PREVOST

**SAFETY
RECALL**

SR23-310A

DATE :	August 2023	SECTION :	18 BODY
SUBJECT:	SEAT RECLINE MECHANISM PIVOT BOLTS

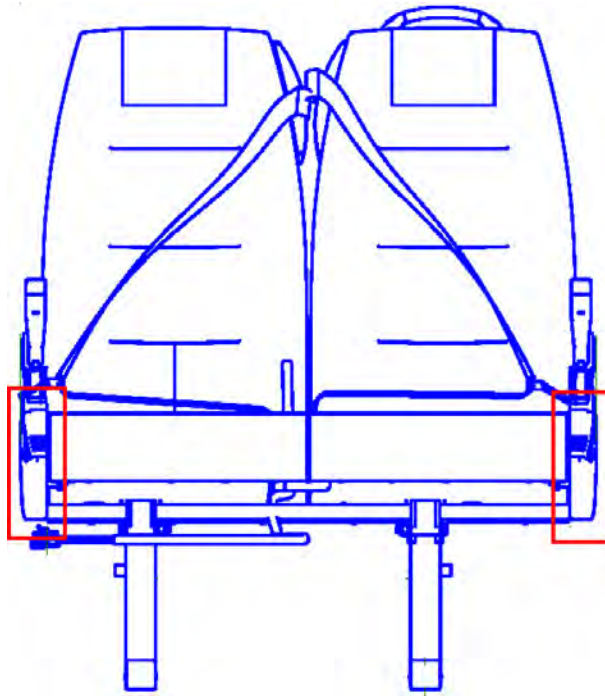
Only the stationary flip up seat (see seat #9) are concerned by this issue (distinct recline mechanism design).

There are 4 potentially defective seats in each vehicle (stationary flip up seats – see seat #9 above).
Each seatback is secured with 1 bolt => 4 potentially concerned bolts per vehicle.

USSC SOLUTION : Add high-strength threadlocker (red) to flip-up pivot bolts.

Bolts on both sides are covered by trim panels

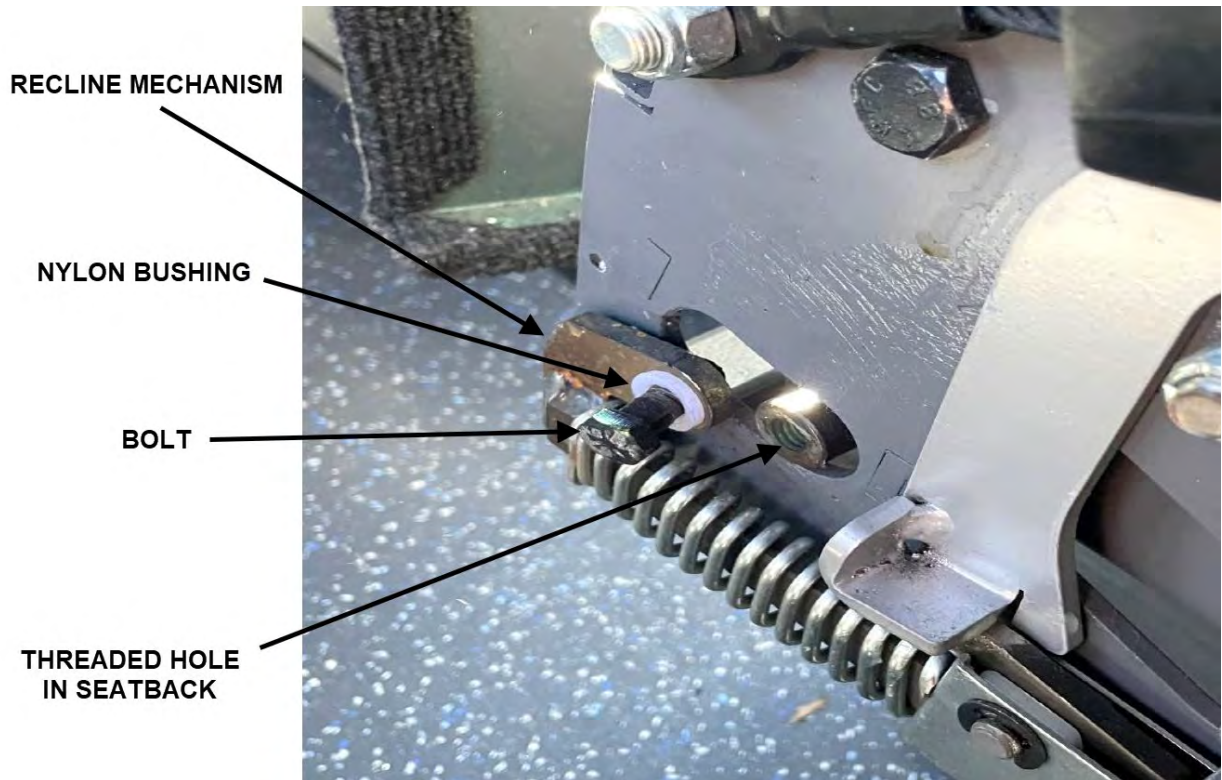
- Remove the trim panel.
- Remove the pivot bolt.
- Add a good quality, high-strength thread-locking adhesive to the bolt threads.
- Reinstall the pivot bolt (tighten firmly).
- Reinstall the trim panel.
- Repeat for all seat bolts concerned.
